HISTORIC AND DESIGN REVIEW COMMISSION

September 18, 2019

HDRC CASE NO: 2019-531
ADDRESS: 1518 E GRAYSON ST
LEGAL DESCRIPTION: NCB 1258 BLK LOT A3
ZONING: C-2 IDZ, H
CITY COUNCIL DIST.: 2
DISTRICT: Government Hill Historic District
APPLICANT: Timothy Cone
OWNER: Tim Sanford/1518 GRAYSON LLC
TYPE OF WORK: Exterior modifications, Historic Tax Certification
APPLICATION RECEIVED: September 06, 2019
60-DAY REVIEW: November 04, 2019
CASE MANAGER: Edward Hall

The applicant is requesting a Certificate of Appropriateness for approval to:

① WALL SECTION @ GRAYSON STOREFRONT
1/4" = 1'-0"

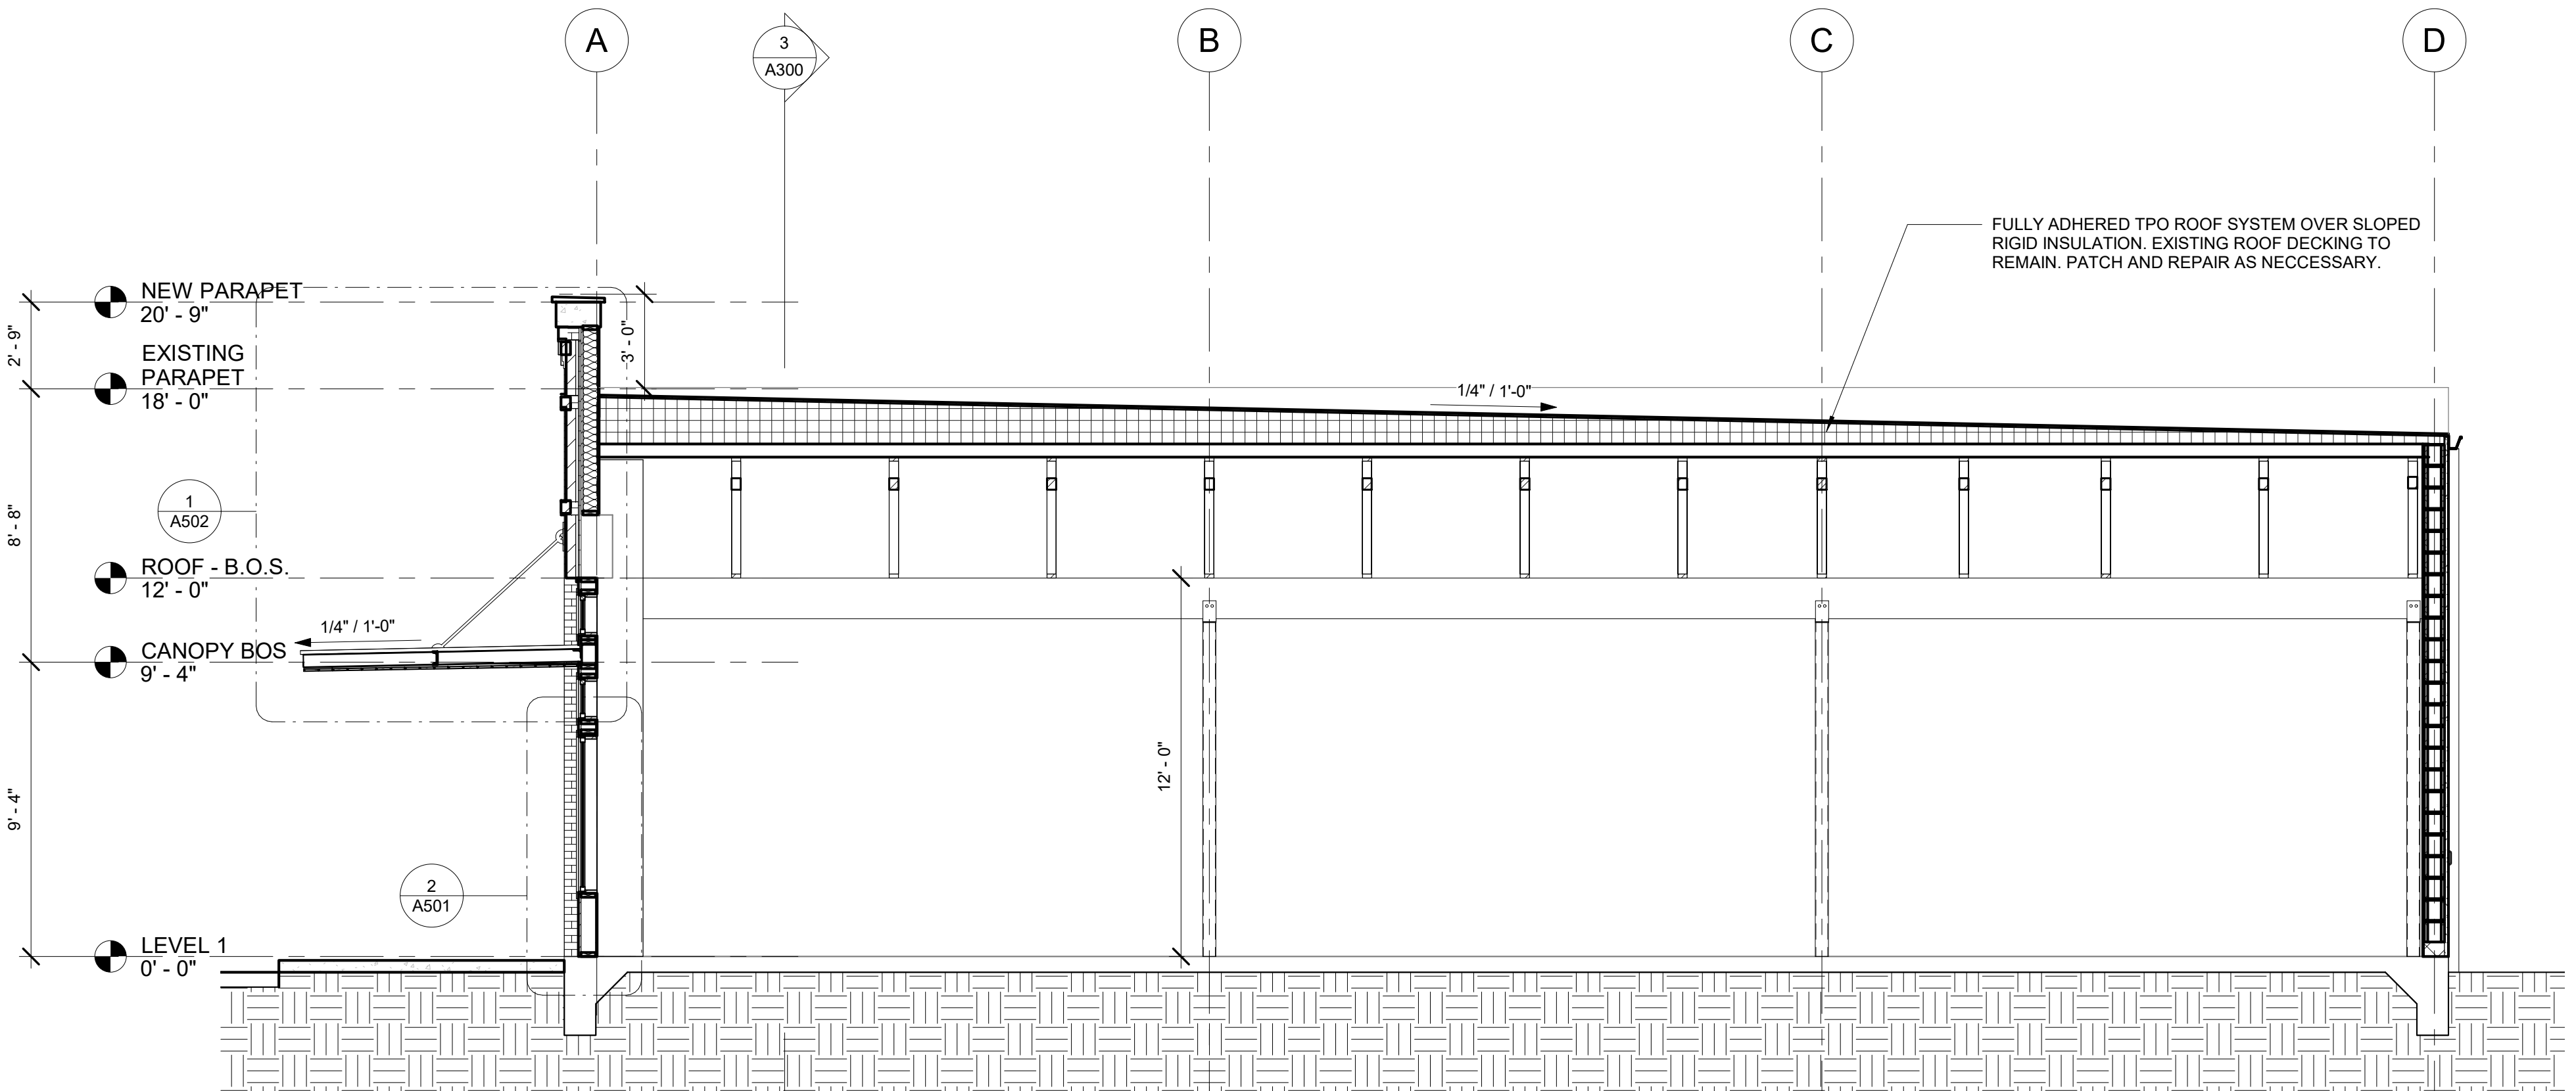
- c. **STOREFRONT SYSTEM** – The applicant has proposed to replace the existing, non-original storefront system. The applicant has proposed a glazed aluminum storefront system to feature pony walls and transom lights that are located and scaled appropriately; however, staff finds that the storefront system beneath the transom should not feature multiple vertical storefront panels. Staff finds that the proposed storefront system should feature dark mullions and frames.

- i. That the proposed storefront system feature dark frames and mullions, and that only one vertical storefront panel should be installed beneath the canopy, rather than one large and one small panel beneath the canopy as proposed.
